RESPONSE TO SUBMISSIONS

INNER SYDNEY HIGH SCHOOL (SSD 7610)

Figure 1 – Demolition Plan

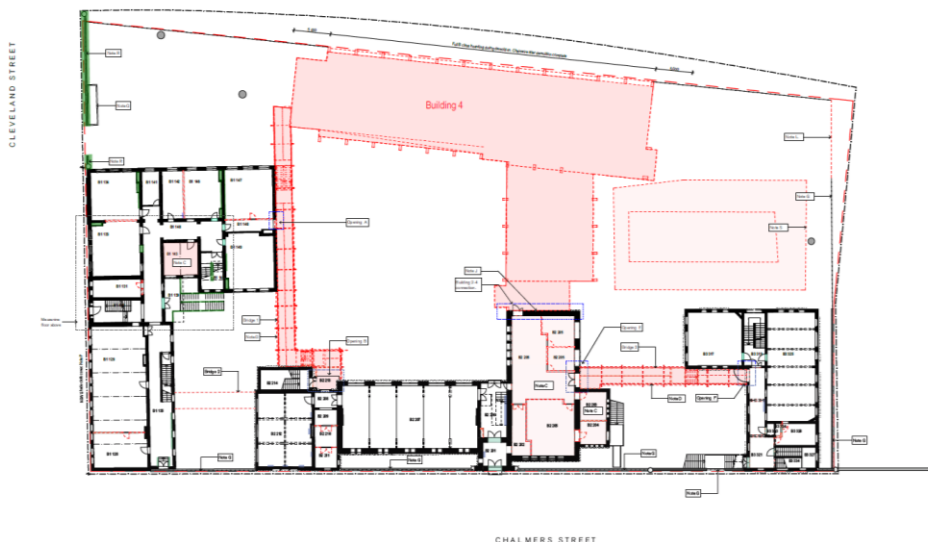
The proposal includes demolition of the 1960s building and the removal of all connecting bridge links on site. The location of Building 4 is shown on the demolition plan below and in Figure 1.

Figure 4 – Tree Removal Plan (FJMT)

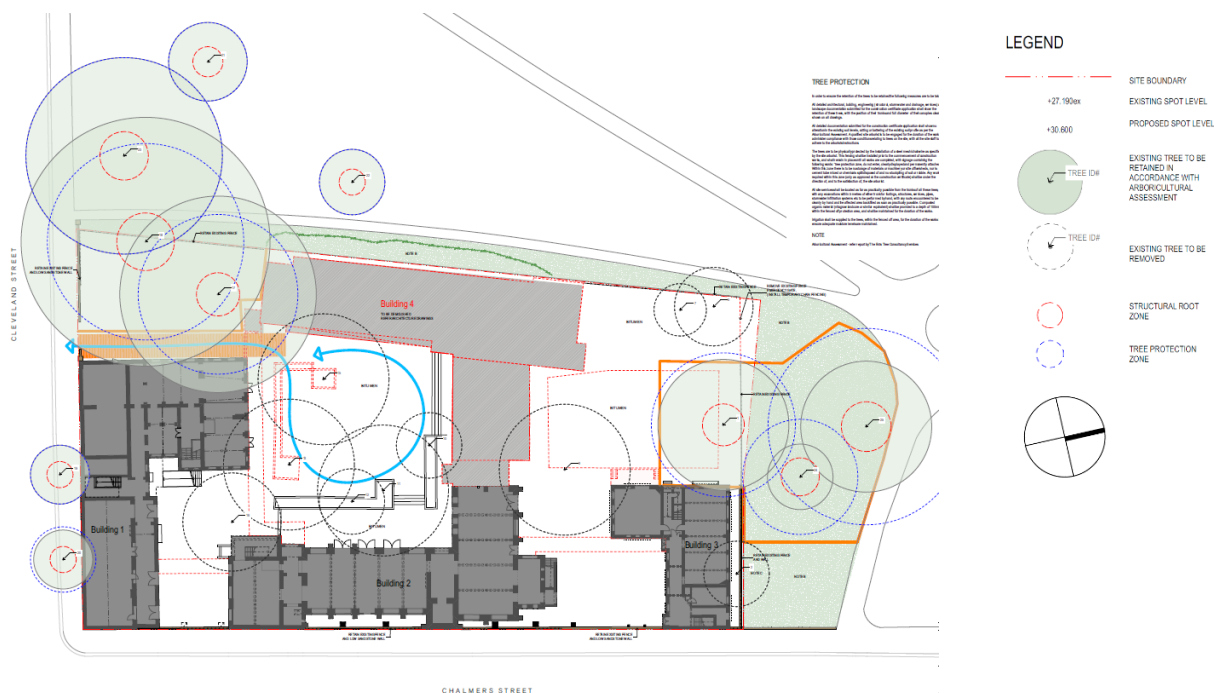
Some tree removal is required to facilitate the demolition of Building 4 and the construction of the new building. The proposal will remove 15 trees and retain 10 trees on and adjoining the site (see Figure 4).

Figure 5 - 188 Chalmers Street – Shadow Impacts (Existing, SSD and Proposed)

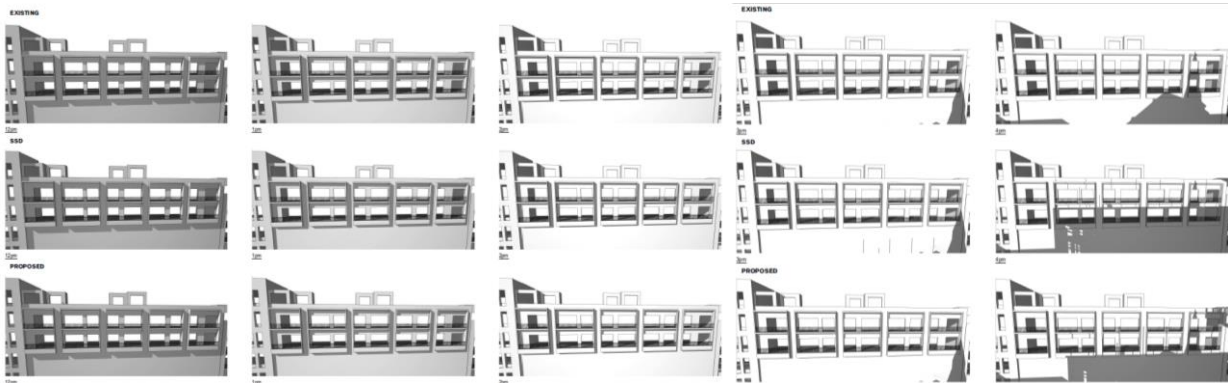
General	An elevational shadow diagram should be provided for each neighbouring residential building.	Elevational shadow diagrams have been prepared and provided.	Section 5.6 Appendix P
	Should construction be required outside of standard hours, this should be explained and justified.	<p>Construction hours provided in the Preliminary Construction Management Plan are:</p> <ul style="list-style-type: none"> Monday to Friday: 7am to 6pm Saturday: 7am to 5pm <p>These construction hours are outside the City of Sydney standard hours of 7:30am-5:30pm and 7:30am-3:30pm. Limited vehicle movements in and out of the site will be</p>	Appendix C and Original SSD PCMP

- **188 Chalmers Street** – No change from existing scenario between 12pm-3pm; Reduction in shadow impact at 4pm compared with the originally submitted SSD (refer to Figure 5 below). In this regard, it is considered that there is no significant impact on residential apartments.
